G702 BEQ Replacement CL

Marine Corps Base, Camp Lejeune, NC
Structural Interior Design Package
Sealed Final Submittal
May 2026

Project: Repair BEQ G702
Meeting: 50% Review Meeting
Date: December 2nd, 2025
Location: Microsoft Teams Meeting

Project: Repair BEQ G702
Meeting: Prefinal Review Meeting
Date: April 7th, 2026
Location: 1005 Michael Road, Camp Lejeune, NC.

A1 1ST FLOOR FINISH PLAN

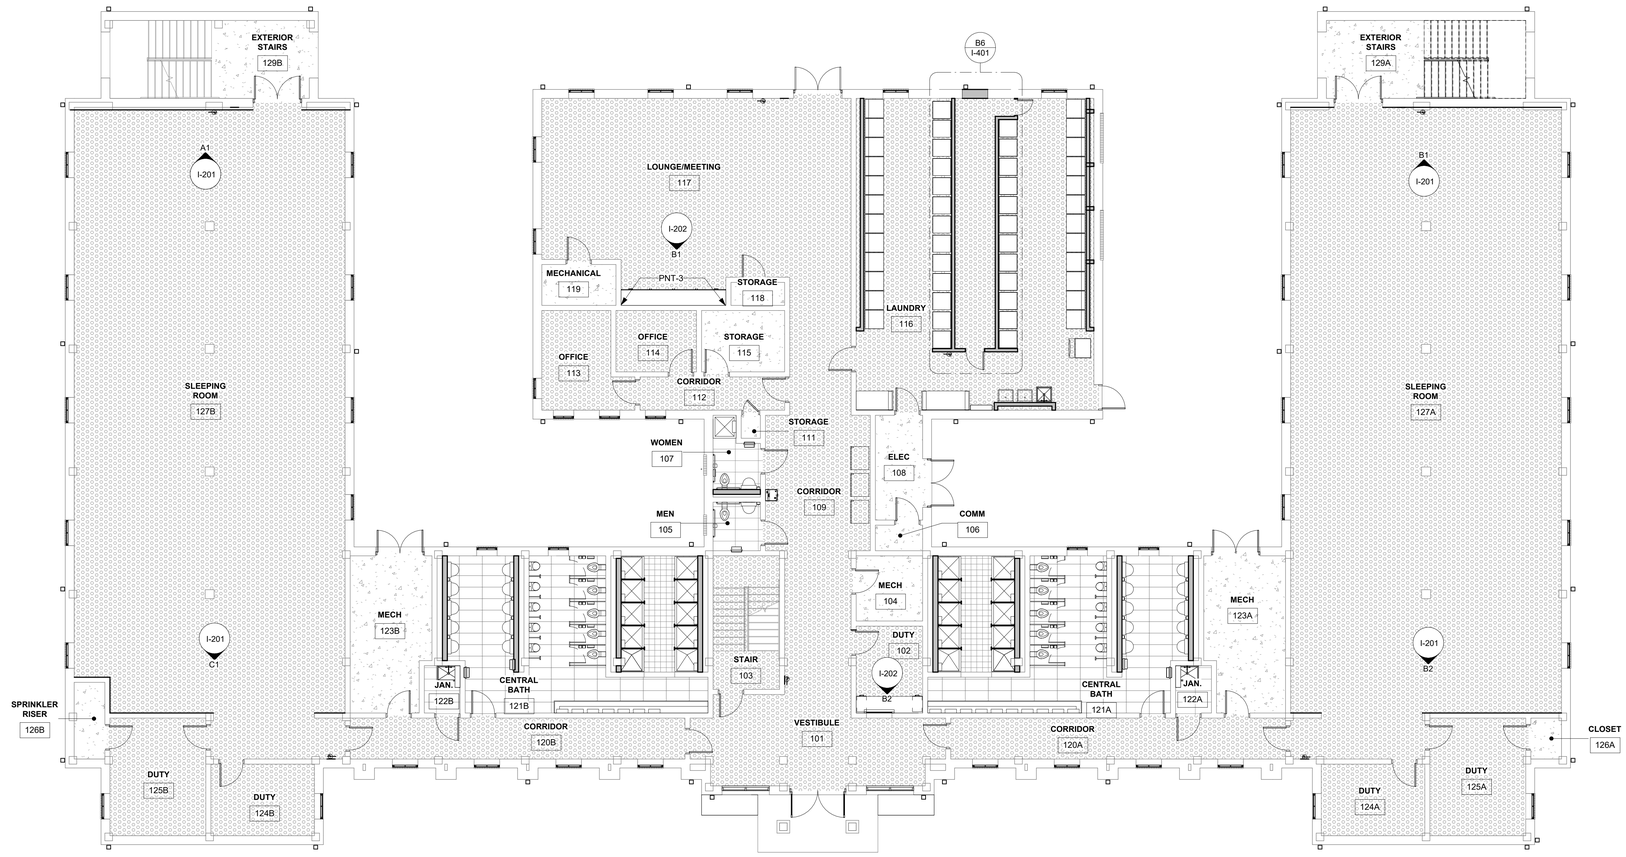
ID #2103251 Sheet I-101: G702 and G703 Do the showers in both/all central baths have the first two needing tile on the floor? As opposed to a solid-surface pan? Are all the showers to be tiled on the shower floors?

Response: Concur. Finishes will be updated.

A1 1ST FLOOR SIGNAGE PLAN

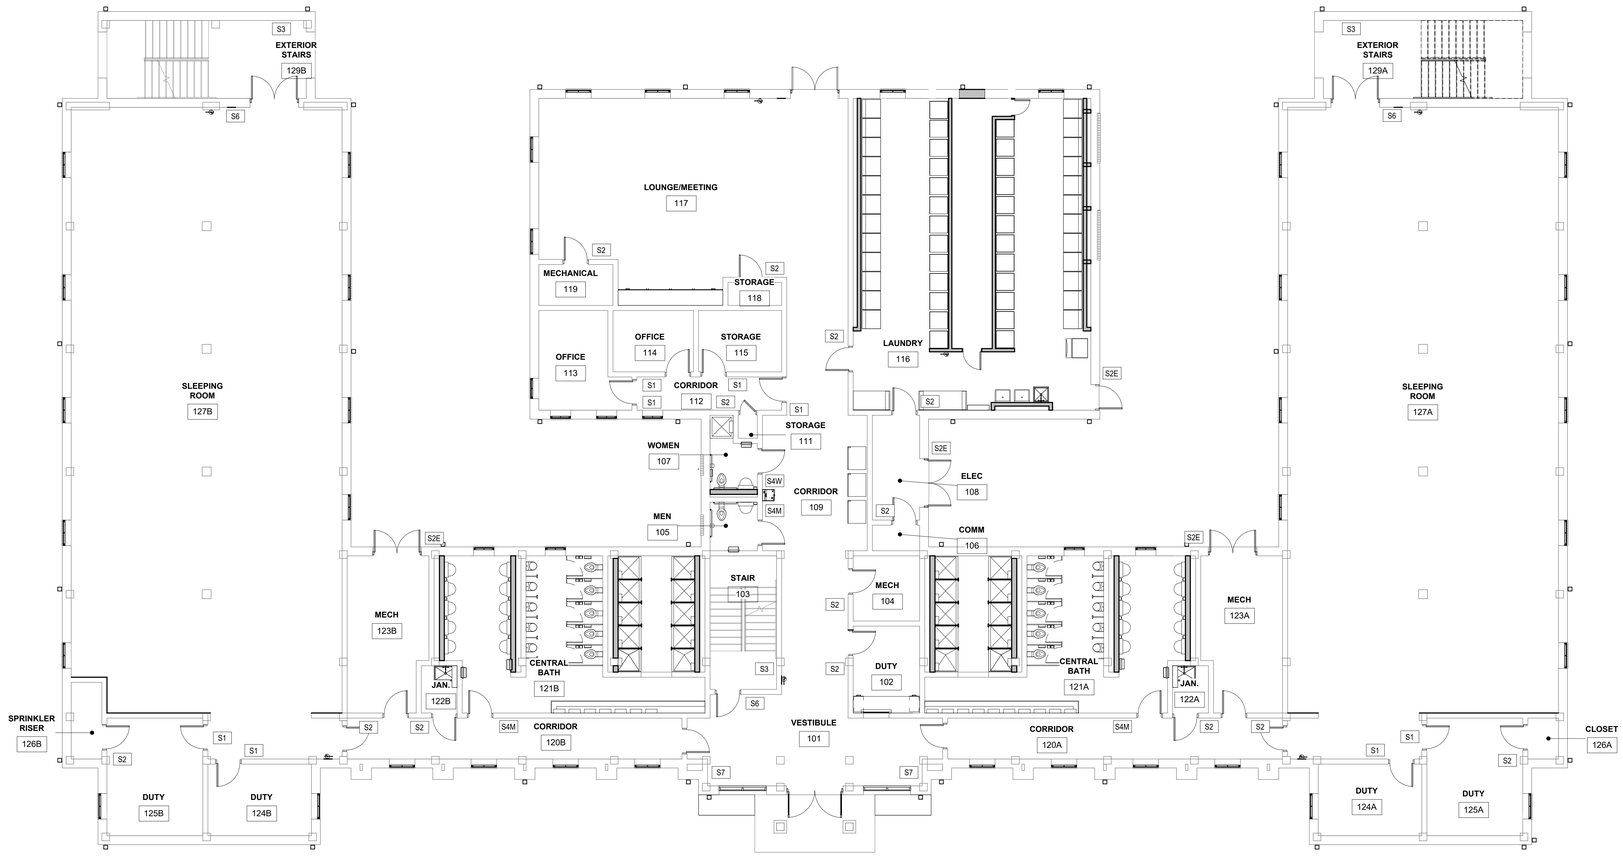
ID #2103256 Sheet I-111: G702 and G703 Fix double pasting of double doors leading to exterior stairwells.

Response: Concur. Extra door has been removed.
